PUBLIC INTEREST REVIEW FOR GROUNDWATER APPLICATIONS

TO: Water Rights Section Date 03/29/2017
 FROM: Groundwater Section Jen Woody
 Reviewer's Name
 SUBJECT: Application [REDACTED] Supersedes review of n/a
 Date of Review(s)

A. GENERAL INFORMATION: Applicant's Name: Willow Creek Dairy c/o Greg te Velde County: Morrow

Figure 2. Groundwater level data expressed in feet above mean sea level (ft amsl) show the subject site's alluvial groundwater levels are above those located in the center of the Ordnance Gravel Critical Groundwater Area, approximately 4 miles to the northeast.

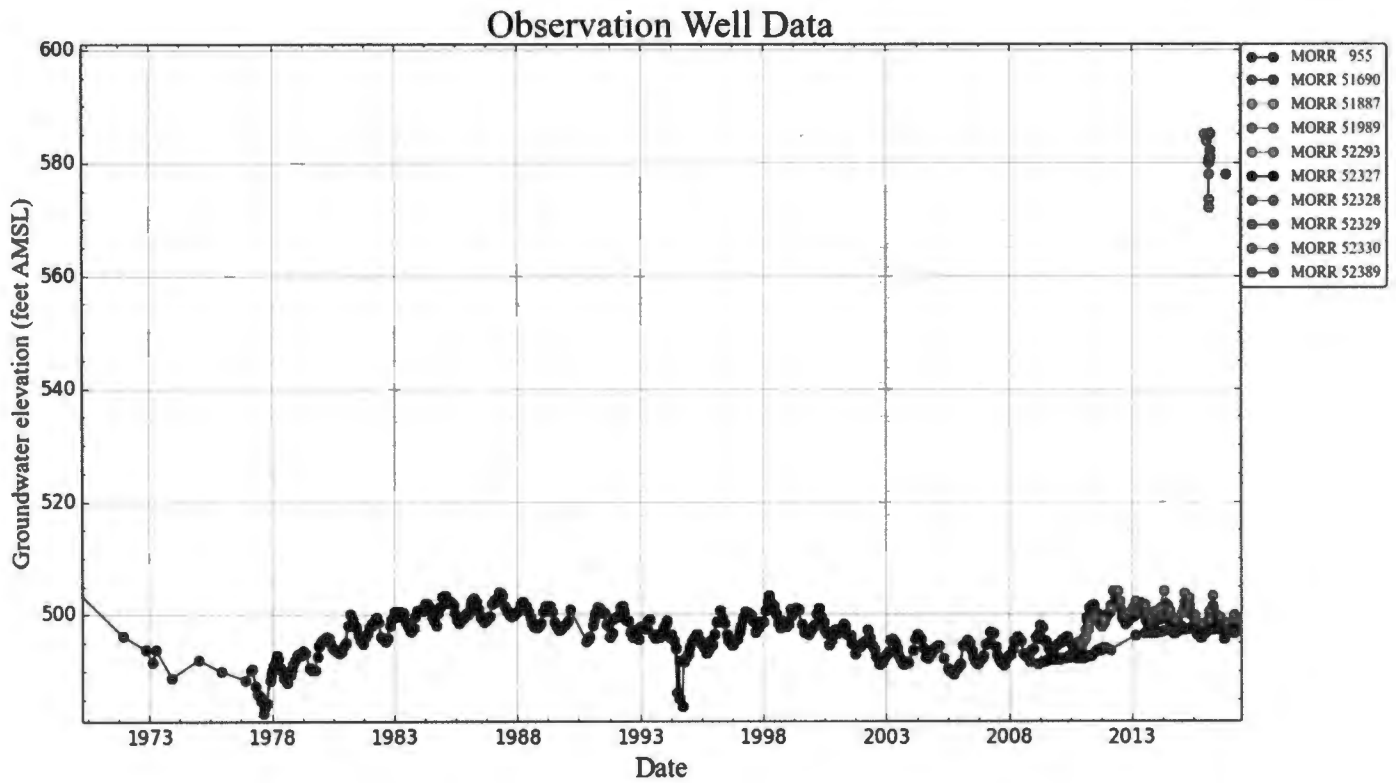
The proposed POAs are located less than one mile outside the Ordinance Gravel CGWA, and the groundwater level elevation at sedimentary wells on the subject site are above that of gravel Critical Area wells. More distant water level data (5-6 miles to the northeast) show Ordinance Gravel CGWA trends are relatively stable at current levels of use and artificial groundwater recharge (see Figure 2). The stability of the groundwater resource depends on artificial groundwater recharge conducted annually by the County Line Water Improvement District. The sedimentary aquifer is sensitive to overdraft and fully appropriated within the boundaries of the CGWA. The proposed use will likely intercept groundwater that would otherwise flow into the critical area, so new long-term uses are not likely feasible without injury to other users.
